Subject: Ninety-Degree Elbow Kits are Available to Connect Squeegee Vacuum Hoses to Squeegees

Models Affected: Focus II L17/L20/S20; BOOST L20

ECO#: ODM 3883

Figure 2 – Squeegee Vacuum Hose Connected to Squeegee with 90° Elbow

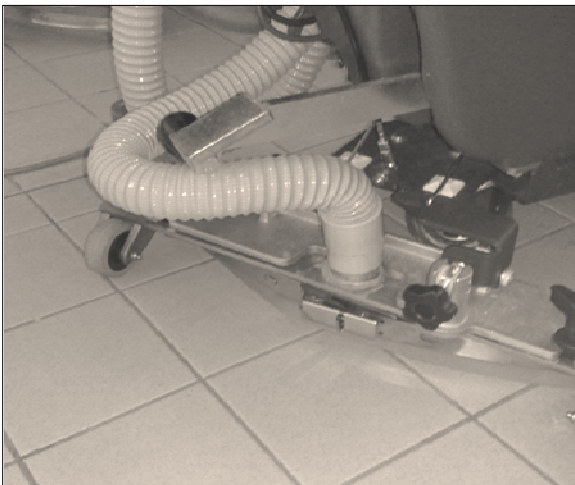
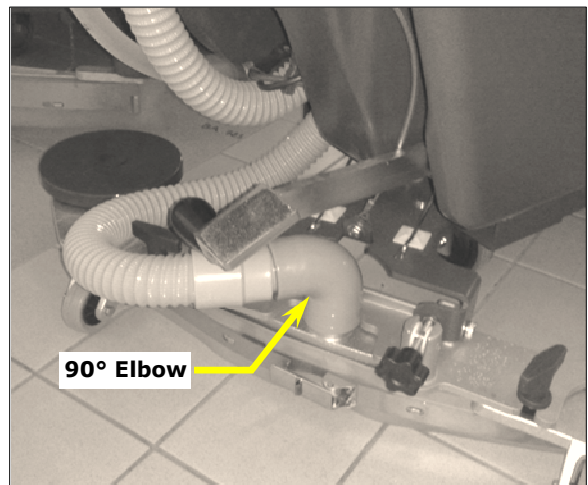
Information Bulletin: See Figures 1 and 2 below. A new 90-degree elbow kit is available to connect the squeegee vacuum hose to the squeegee. The elbow helps prevent the brush lifting pedal from interfering with the squeegee hose when the machine is used for drying only (brushes lifted upward and the pedal in the lowered position).

Issue: Brush lifting pedal interfering with the squeegee vacuum hose.

Cause: The vertical squeegee vacuum hose connection to the squeegee positions the hose such that it can interfere with the brush lifting pedal under certain circumstances.

Corrective Action: Field: If you frequently use the machine for drying only with the squeegee down and the brushes retracted upward, you may find it convenient to install the accessory 90-degree elbow kit. The kits are available in black and gray as follows:

- 90-degree elbow kit, gray – p/n 9098853000
- 90-degree elbow kit, black – p/n 9098854000
